Item No.
Regional Centre Community Council
July 20, 2020

SUBJECT: **Case 22805: Appeal of Site Plan Approval – 1392 to 1444 Seymour Street, Halifax**

Appeal of the Development Officer's decision to issue a Site Plan Approval.

Attachment B - Variation Detail

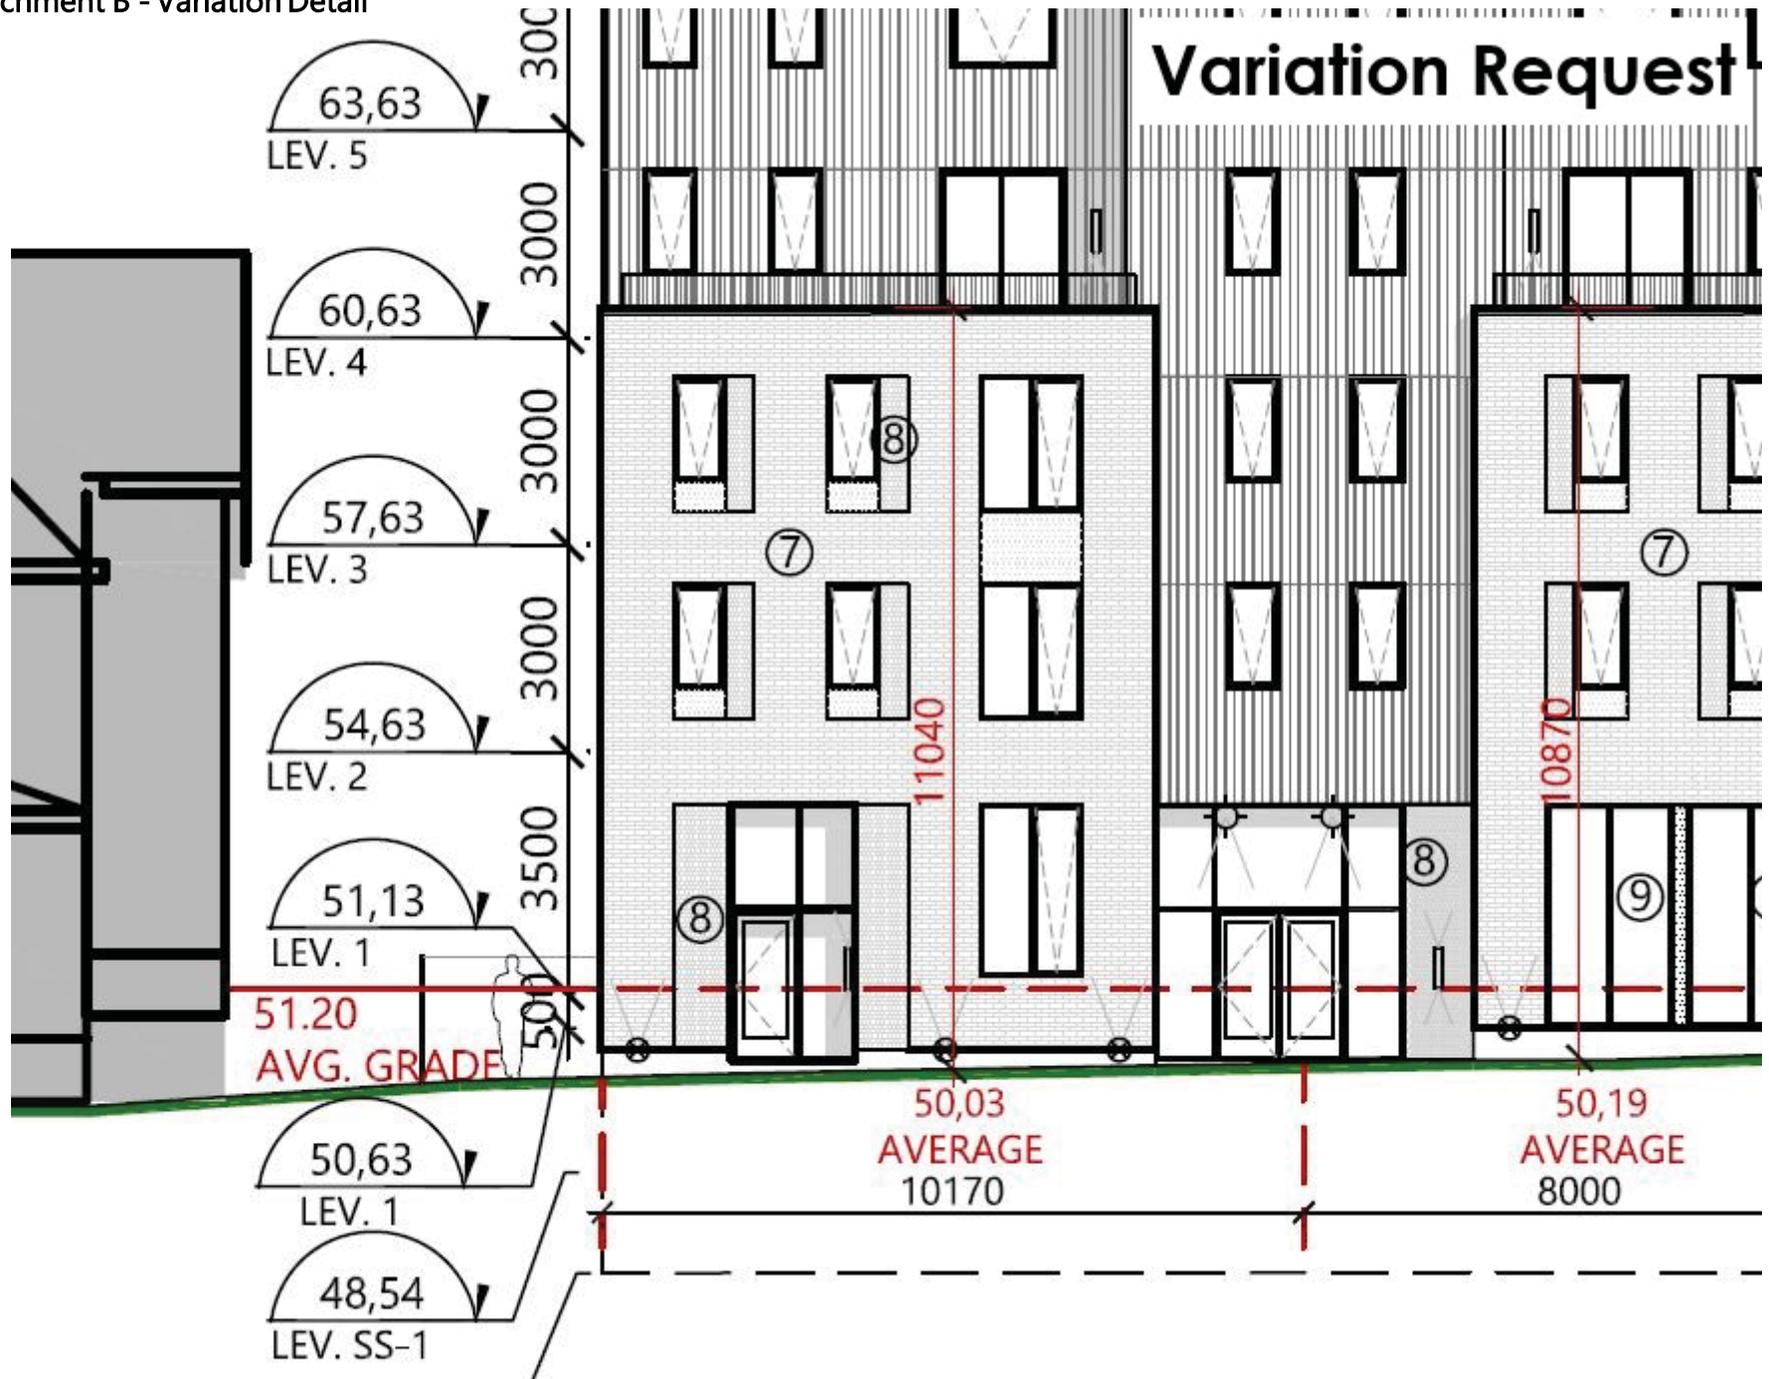
The Regional Centre Land Use By-law permits certain requirements to be varied through Site Plan Approval if the request meets the stated variation criteria. In this proposal, the applicant has requested a variation to increase the maximum streetwall height for a portion of the building by 0.04 m (1.57 in.). The detail of the variation request is as identified below:

Zone Requirement	Variation Requested
Maximum Streetwall Height	11.00 meters	11.04 meters

Based on the sloping conditions of the site as shown in Attachment B, staff determined the variation request was consistent with the approval criteria and was of an extent that was inconsequential with respect to impact on the building design or surrounding property.
